Local Planning Panel

Site: 132-138 McEvoy Street, Alexandria

Application No: D/2018/1615

proposal

issues – stormwater culvert

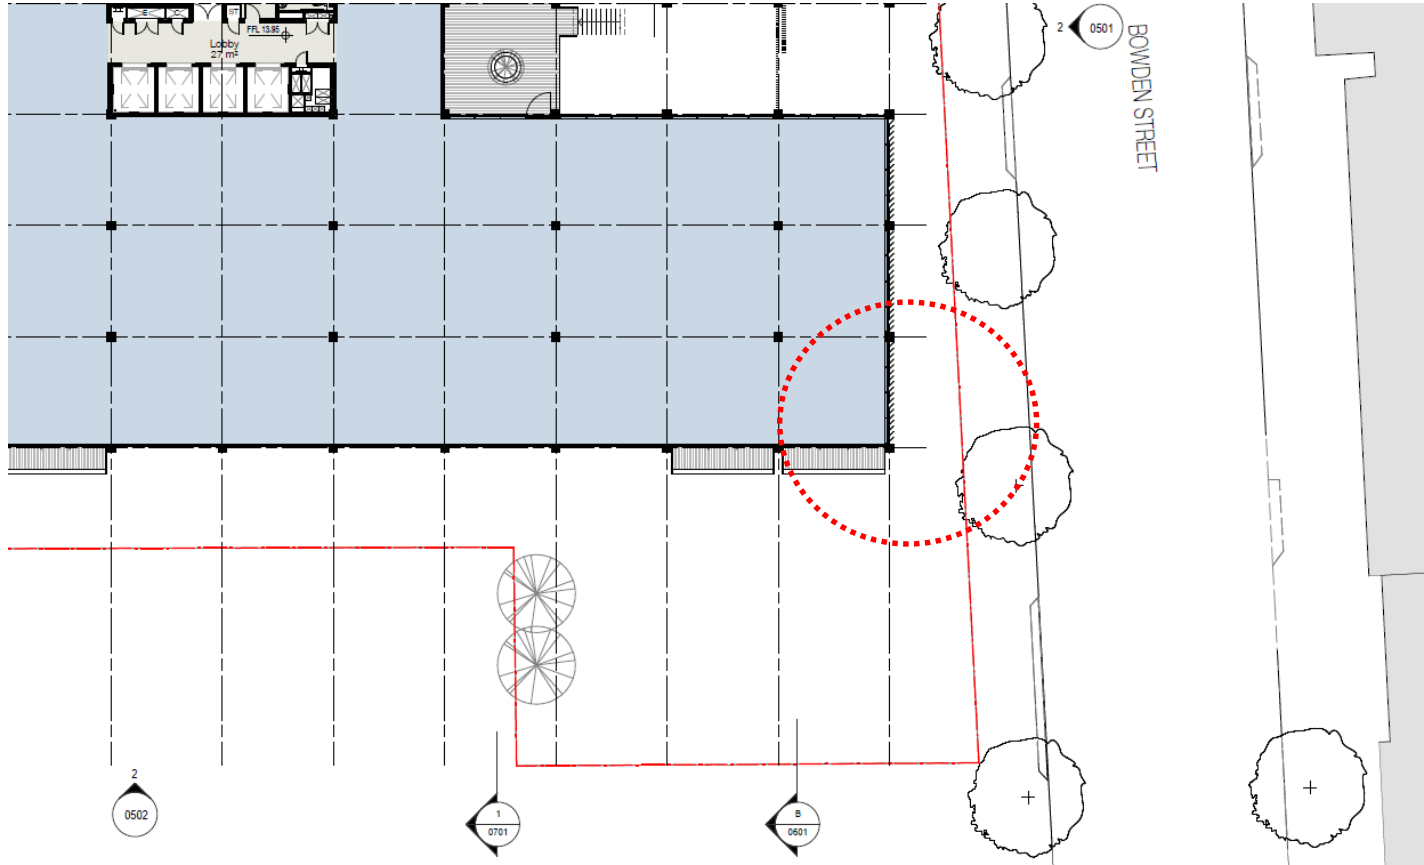
- Sydney Water advised no structures to be built above their stormwater infrastructure and easement
- proposed development includes structural support and cantilevered office floor space over Sydney Water's culvert
- deferred commencement condition recommended to delete proposed encroachment

issues – deep soil

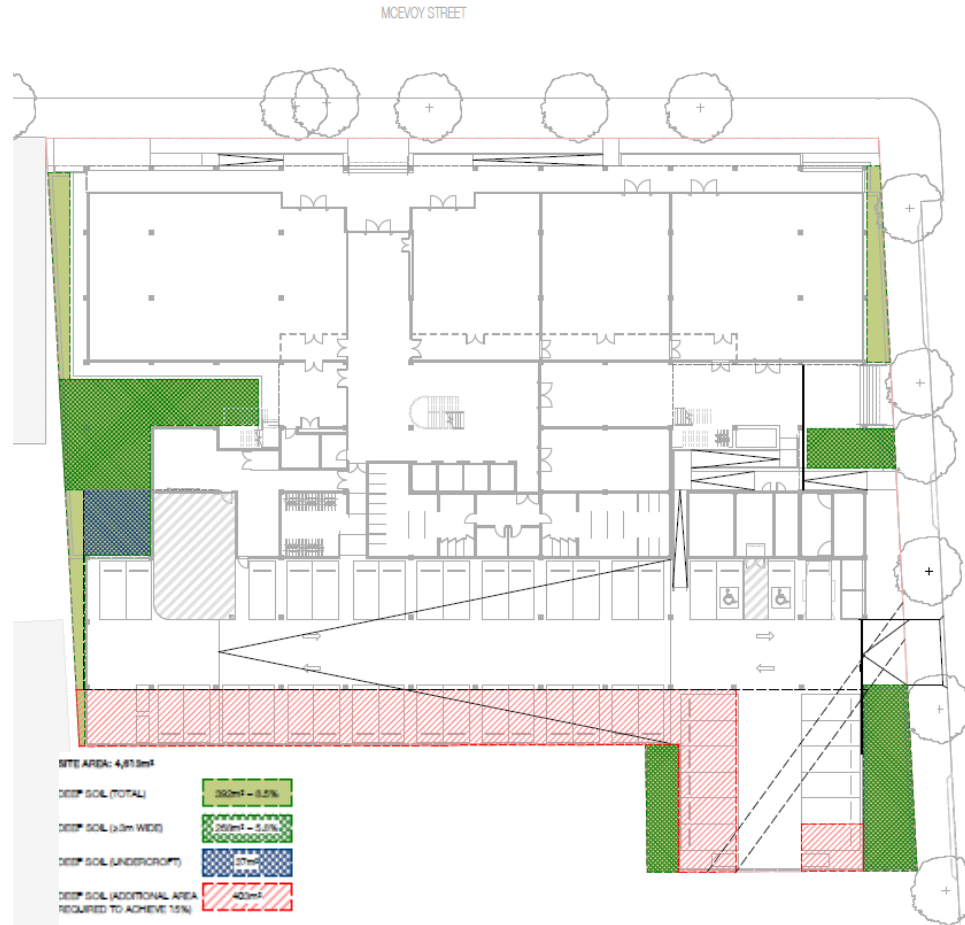
5.8% deep soil

deferred commencement condition to require:

- green roof
- additional plantings
- deep soil areas
- permeable paving to car parking areas

Figure 08: SECTION - North Facade - Fixed Horizontal Shading

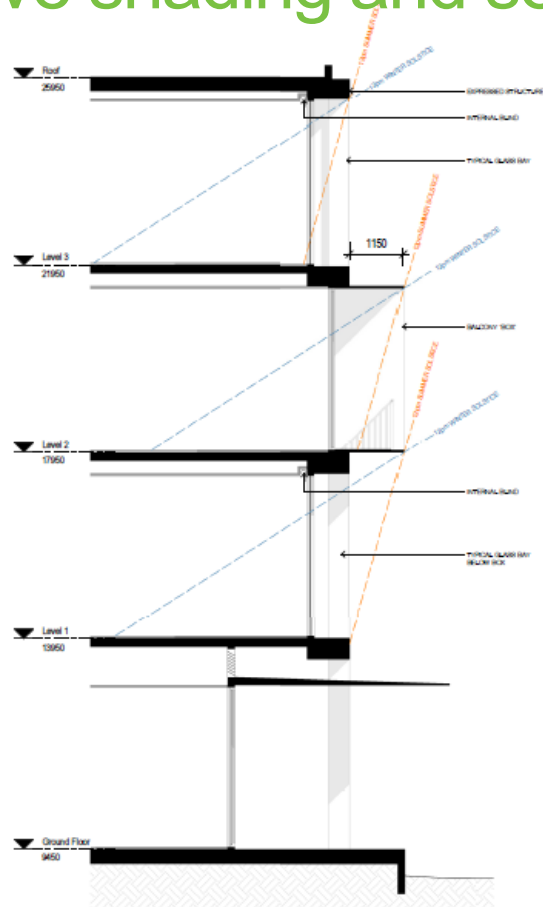
- insufficient external shading provided to building elevations and no rooftop solar panels
- submitted NABERS report recommends additional external shading and solar panels to achieve NABERS 5.5 star rating
- deferred commencement conditions recommended to require additional external shading to building elevations and roof top solar panel array
